City of Mississauga Department Comments

Date Finalized: 2023-06-14 File(s): A195.23

Property Address: 552 Wallenberg Crescent

Appendix 1 – Transportation and Works Comments

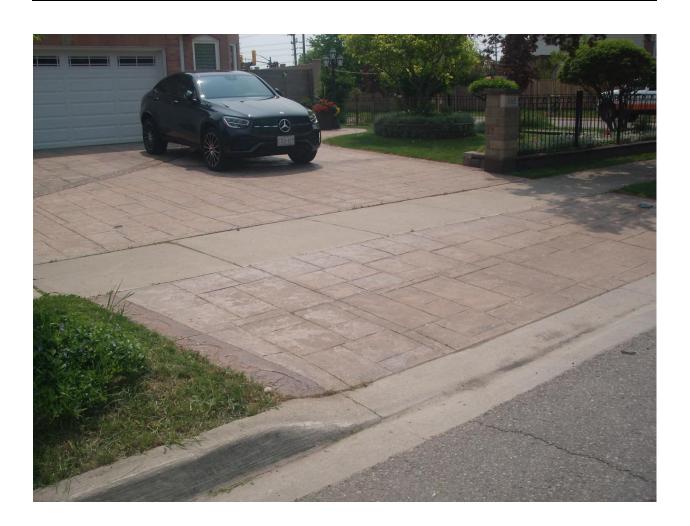
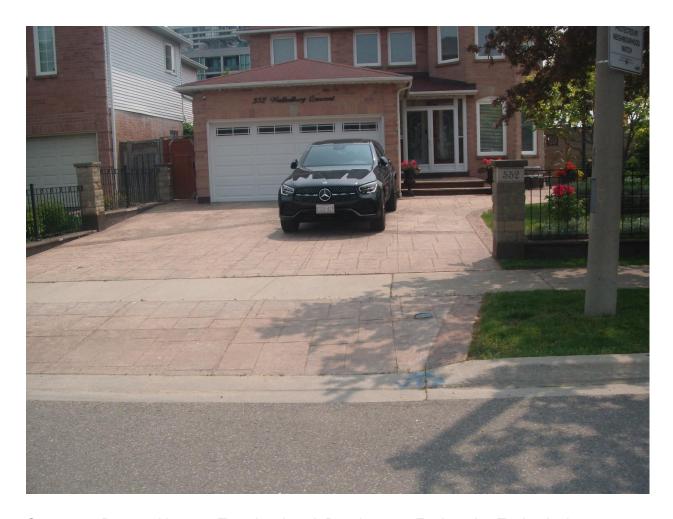
This department notes that with regard to the widened driveway within the municipal boulevard (the area between the municipal curb and property line) we would request that this area be reinstated with topsoil and sod should the application be modified to reflect a smaller driveway width within the subject property or if the application is not supported by the Committee.
